Steepbank Mine Project

Supplemental Information Response

**SUPPLEMENTAL INFORMATION RESPONSE
STEEPBANK MINE PROJECT
EUB APPLICATION NO. 960439
AEP APPLICATION NO. 020-95, AND FILE NO. 27551**

The following information is provided in response to the Energy and Utilities Board and Alberta Environmental Protection supplemental information request dated July 12, 1996. The following response follows the outline of your supplemental request letter.

FIGURE 4.5-1

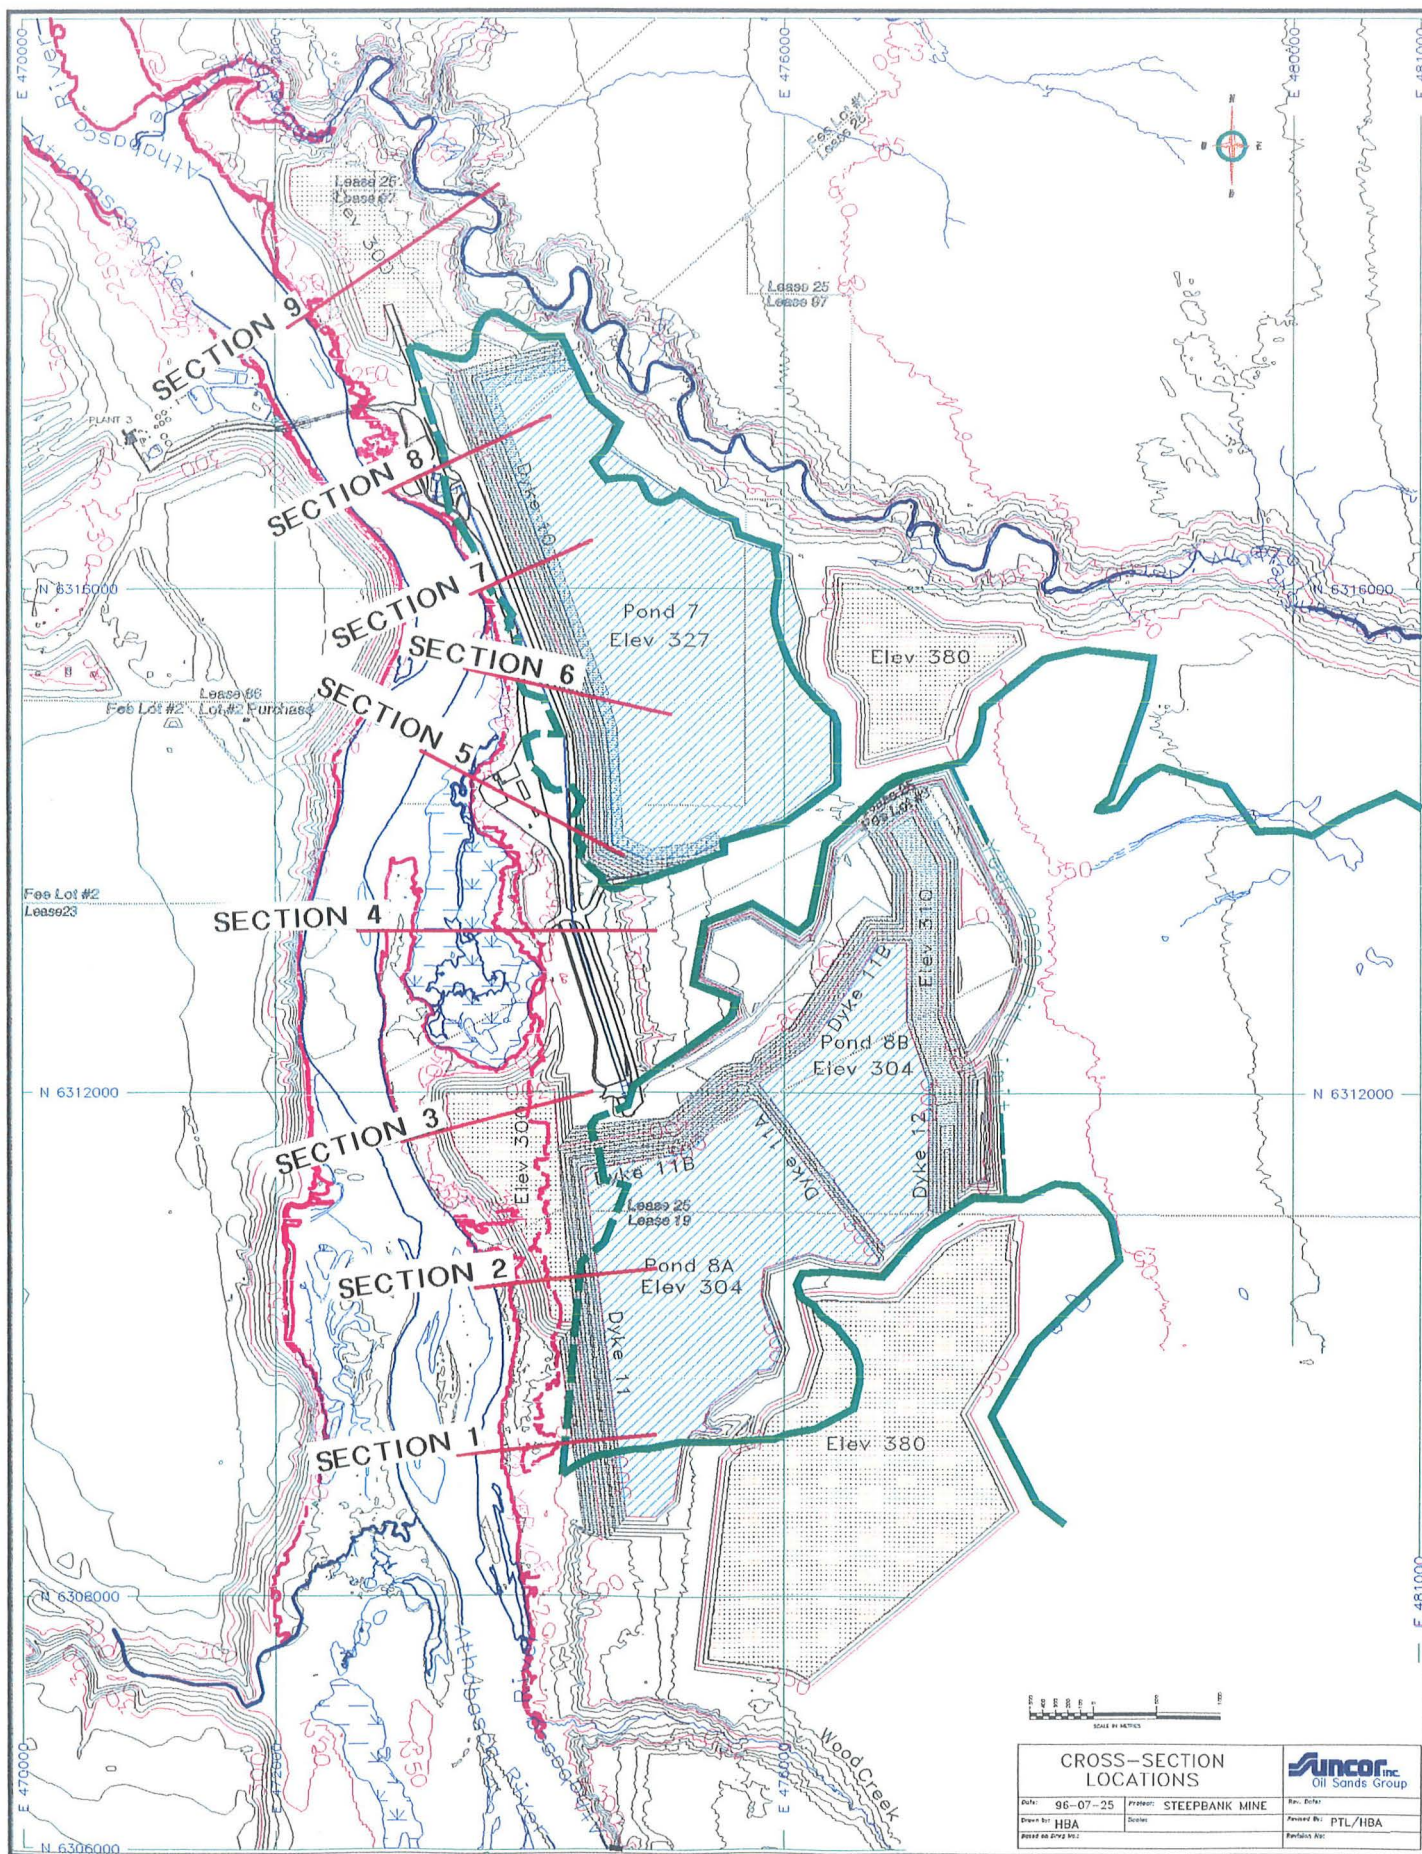
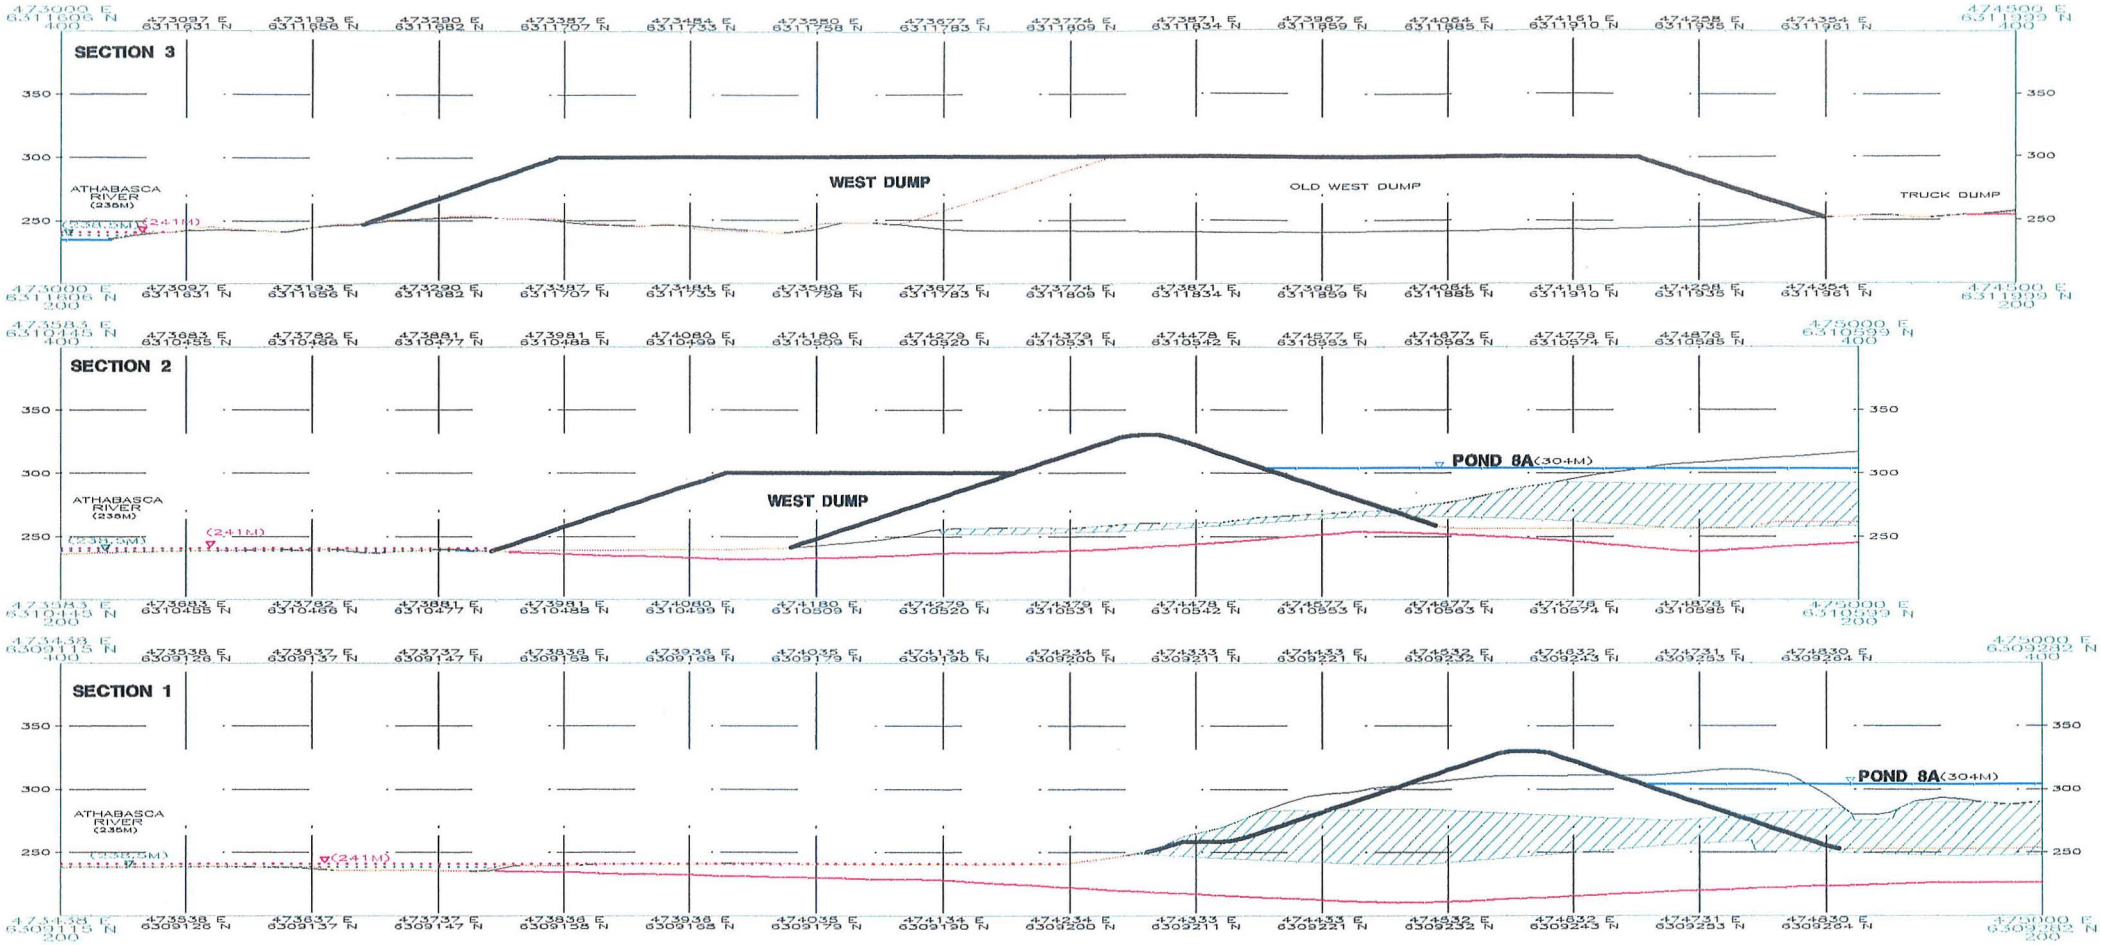
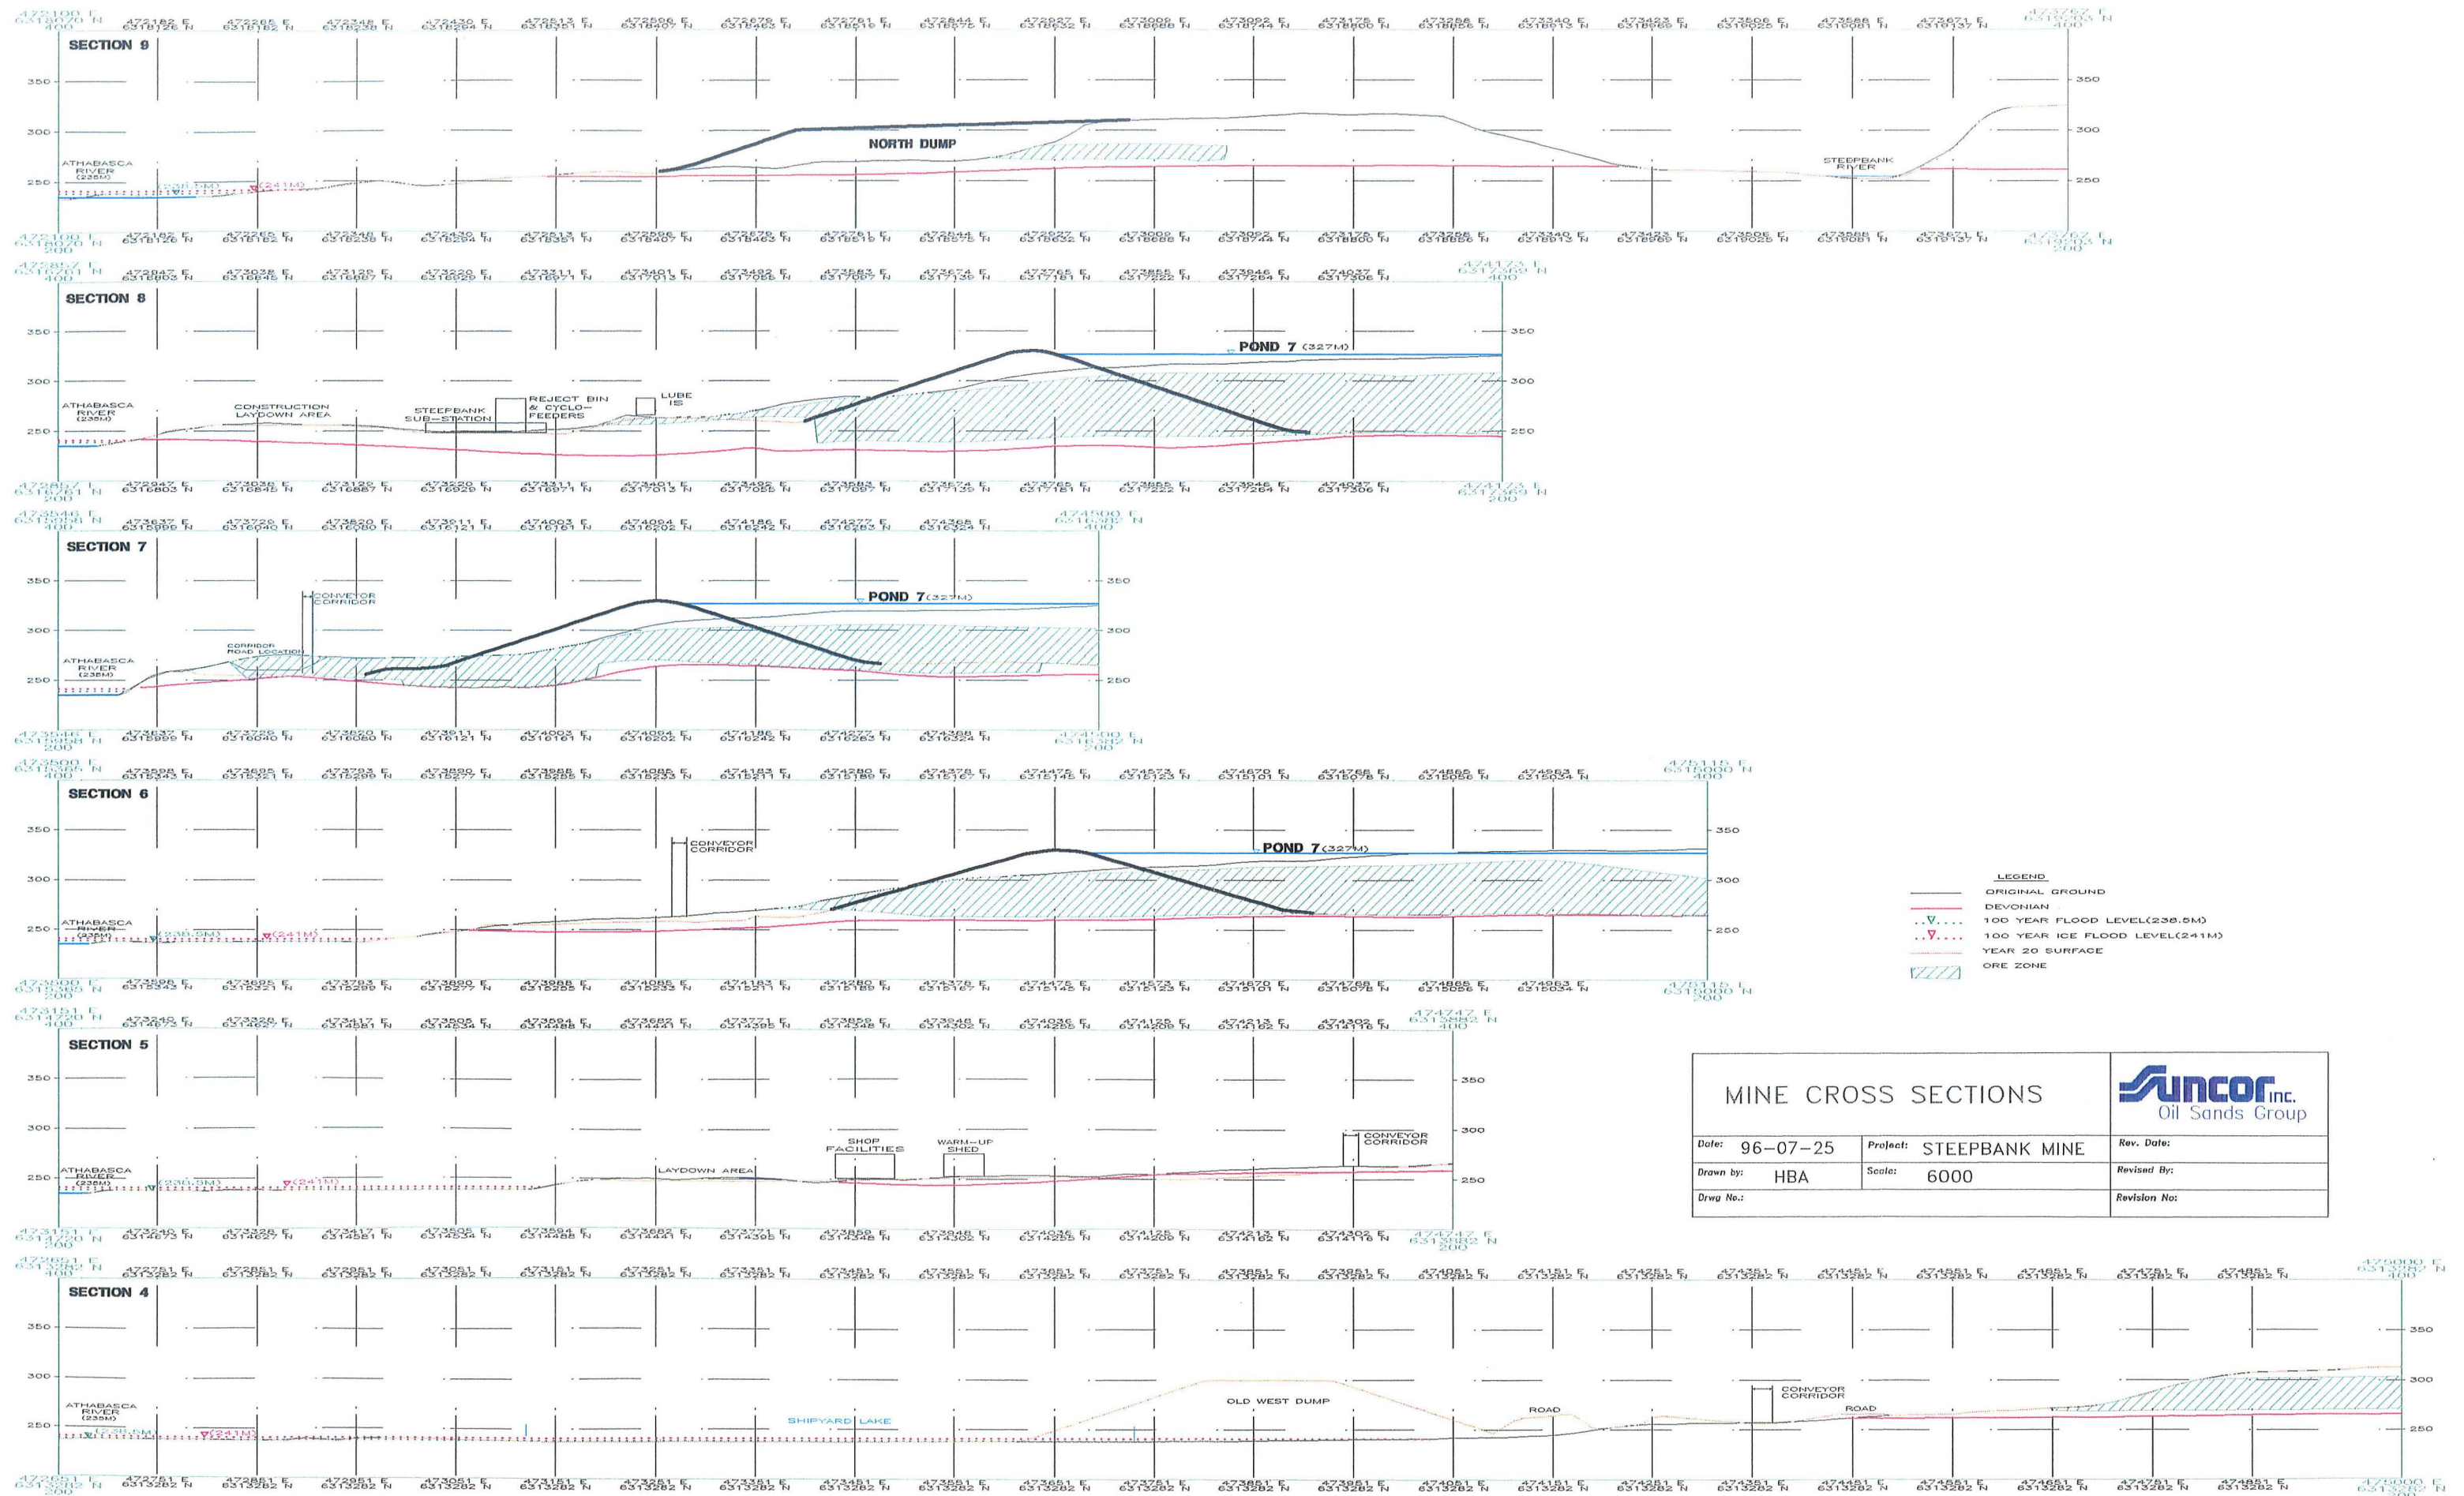
- c) **Document how the 70 m setback conforms to the floodplain (setback to the 1:100 year flood level) values in the Integrated Resource Plan. Demonstrate that development within the water flood and ice flood contours will be adequately protected from flood damage and that it will not worsen flood conditions in other floodplain areas (for example, due to placement of overburden or other terrain modification within the floodplain). Provide a revised Figure C 4.0-1 showing the impact area of a 1:100 year ice flood.**

Q4.35 Suncor states that the limit of mining will be well above the 1:100 year flood level (*Steepbank Mine Project Application, April 1996, Section A2.0, p.10*). Provide a more detailed contour map (1:20,000 scale) and cross sections through the escarpment area showing the proposed limit of mining in relation to the water and ice flood levels. In addition, advise whether Suncor expects to add provisions for flooding contingencies to its emergency response plan, before excavating close to the flood elevation.

the road and the river, as is illustrated on Figure 4.5-3, Section 7. The river bank was investigated in March 1996 by AGRA Earth & Environmental, to examine erosion concerns along the east bank in the vicinity of proposed facilities. The report describes the "pinch point " as: "High (20 metres plus), steep and stable banks in this area consist of hard tar sand cretaceous material. This tar sand material likely overlies limestone material near river bed level based on the level of limestone in this section identified by Geological Survey of Canada (Norris, 1963). Norris also identified limestone in the section just upstream in the vicinity of the fenland outlet." The stable bank, combined with the road redesign eliminate any concerns for erosion impacts due to the road location.

A4.35 A contour map showing the flood contours in relation to mining boundaries and facilities siting is provided in Figure 1-1. Cross sections through the escarpment area are provided in Figures 4.5-1 to 4.5-3. These figures show that all mining activity, shaded in green, is well above the flood plain.
